## HISTORIC AND DESIGN REVIEW COMMISSION

December 15, 2021

**HDRC CASE NO:** 2021-606  
**ADDRESS:** 130 E ROSEWOOD AVE  
**LEGAL DESCRIPTION:** NCB 6458 BLK 9 LOT 56 AND 57  
**ZONING:** R-5  
**CITY COUNCIL DIST.:** 1  
**DISTRICT:** Monte Vista Historic District  
**APPLICANT:** James MacMillan  
**OWNER:** James MacMillan  
**TYPE OF WORK:** Fenestration modifications  
**APPLICATION RECEIVED:** November 16, 2021  
**60-DAY REVIEW:** Not applicable due to City Council Emergency Orders  
**CASE MANAGER:** Katie Totman  
**REQUEST:**

The applicant is requesting a Certificate of Appropriateness for approval to modify one (1) window opening to install steel casement windows on the west elevation of the main house.

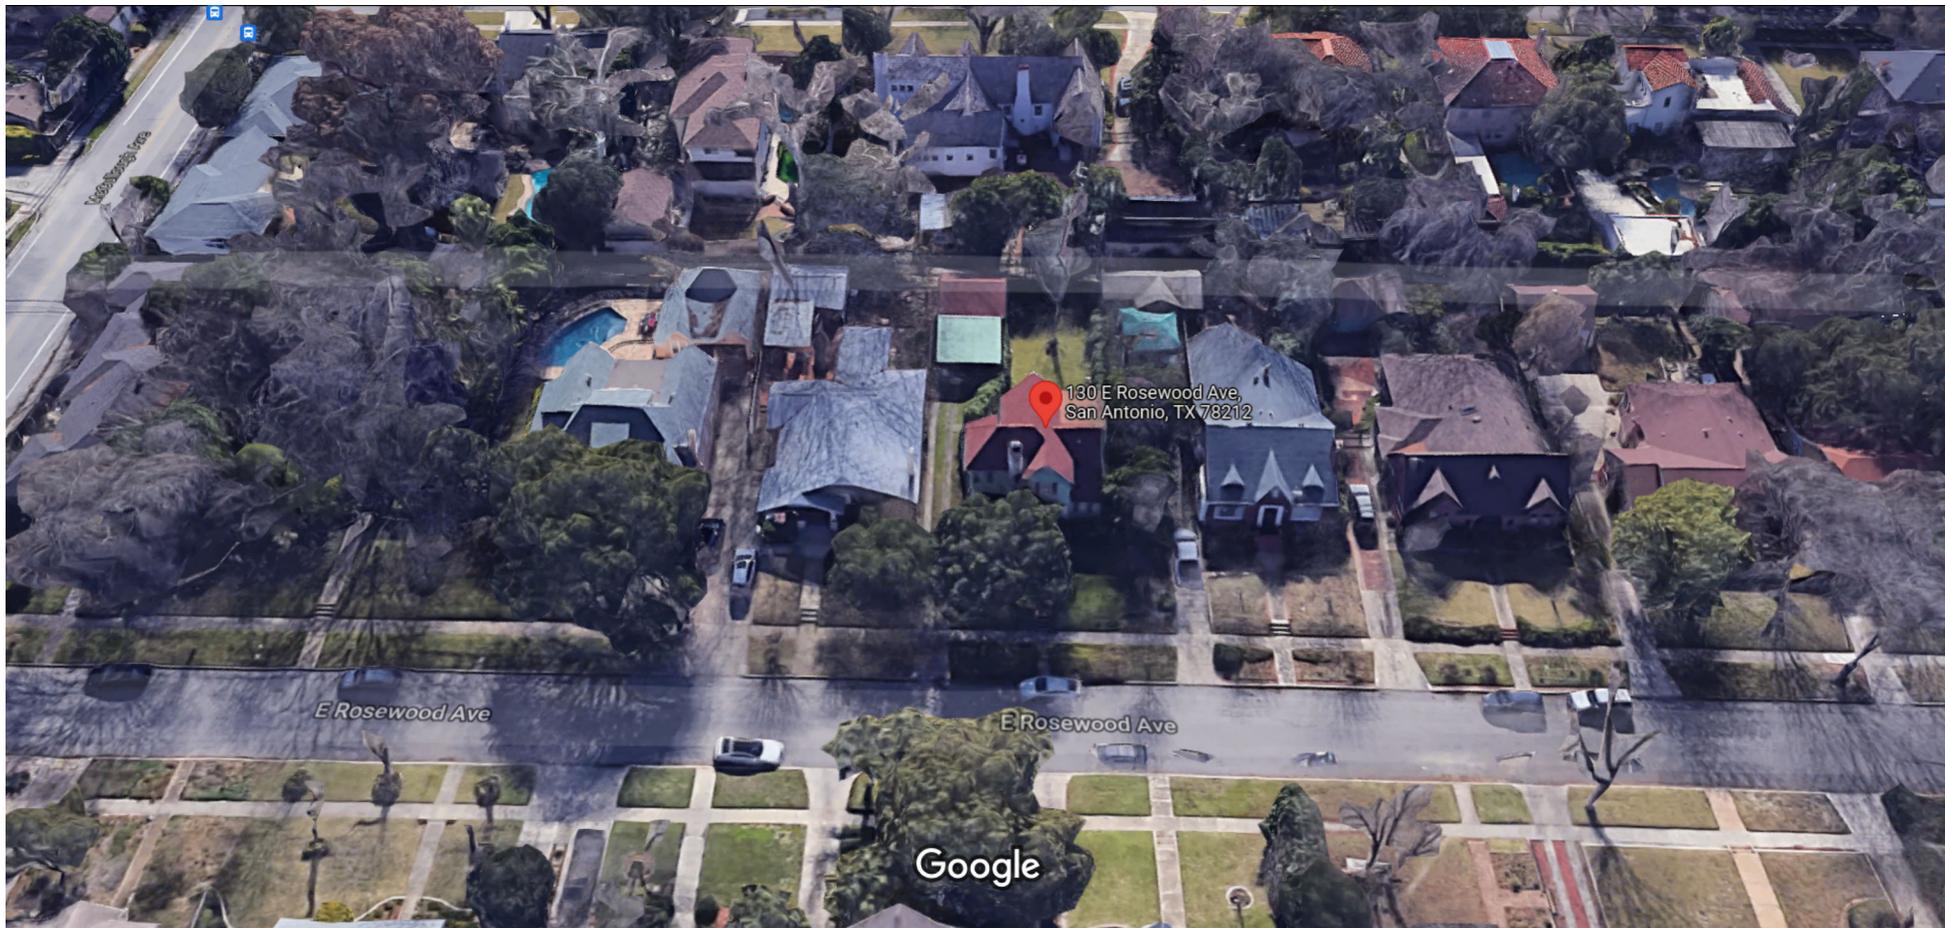
b. WINDOW REPLACEMENT (FIRST FLOOR) – The applicant is proposing to replace one (1) existing wood one over one window located on the west elevation of the house with a salvaged steel casement window. The existing wood window has a smaller proportion relative to the majority of the historic window openings on the primary facade of the home and is located on what staff finds to be a later rear addition based on Sanborn map evidence. The modification will not be easily visible from the public right-of-way. According to the Historic Design Guidelines, new elements should not significantly alter or destroy historic building character. Opening modifications should be compatible and should be appropriate for the building style. The proposed casement window system echoes the rhythm and proportions on the existing structure and will utilize a portion of the existing window frame opening. Staff finds the request acceptable with the stipulations listed in the recommendation.

Staff recommends approval based on finding b. Staff recommends that the wood window that is removed be salvaged or stored on site for future use and that trim and sill detail match the existing.
